PROJECT NO. 35077

FIRST AMENDMENT TO THE ERCOT
STANDARD GENERATION INTERCONNECTION AGREEMENT
BETWEEN CROSS TEXAS TRANSMISSION, LLC
AND MIAMI WIND I, LLC

**FIRST AMENDMENT TO THE
ERCOT STANDARD GENERATION INTERCONNECTION AGREEMENT**

EXHIBIT "C-1" **CONCEPTUAL ONE-LINE OF INTERCONNECTION FACILITIES**

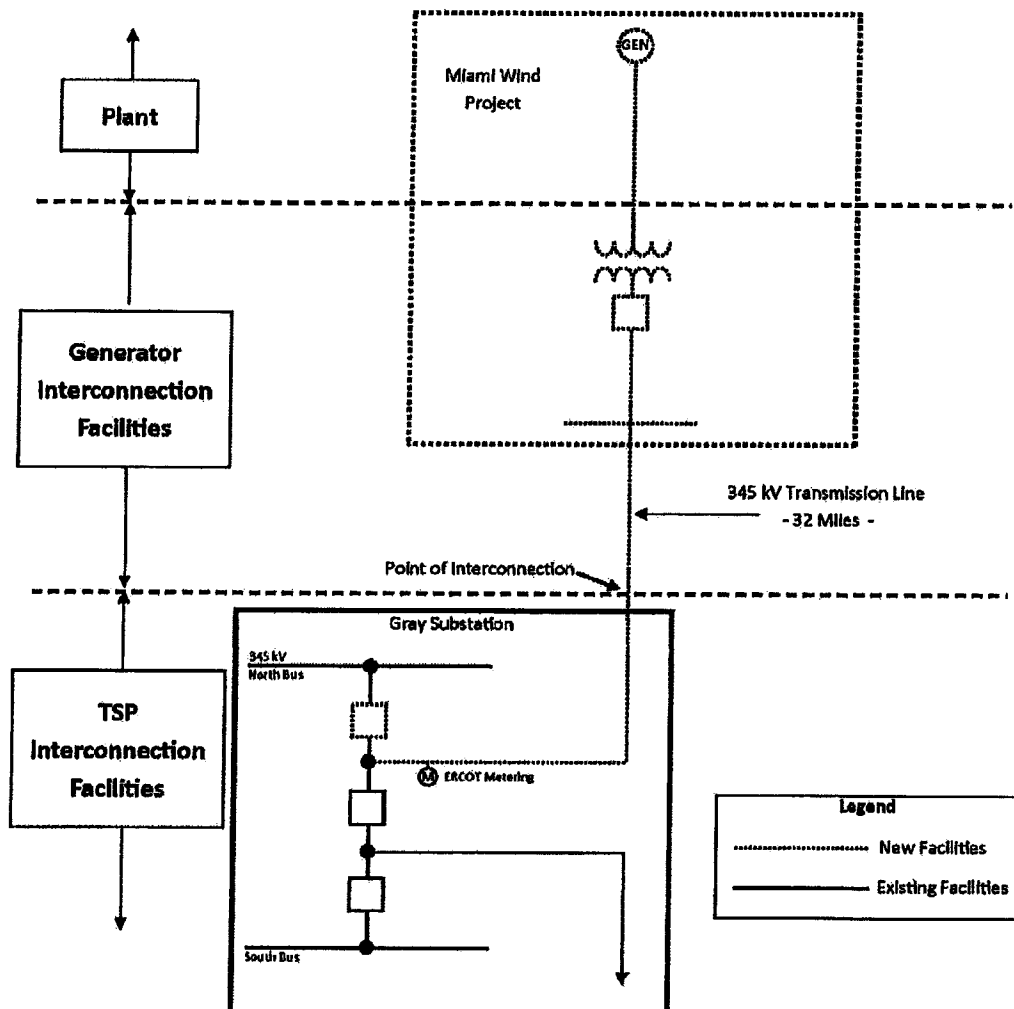
- 1) Name: Miami Wind I, LLC
- 2) Point of Interconnection location: The Point of Interconnection is located in Gray County at 7491 County Road 17, Lefors, Texas 79054 within Cross Texas Transmission's Gray Substation ("TSP Substation"). The Point of Interconnection shall be defined as the point where the Generator's 345 kV transmission line, originating from the Generator's substation, terminates the phase conductors and associated equipment on the TSP's dead-end structure located at the TSP Substation. Exhibit "C-1" shows the location of the Point of Interconnection on the one-line.

- a) ERCOT Polled Settlement ("EPS") metering will be located at the TSP Substation. The metering equipment described below will be procured, owned and installed by the TSP inside the TSP Substation. See Exhibit "C-1" for the location of the ERCOT EPS metering on the one-line.
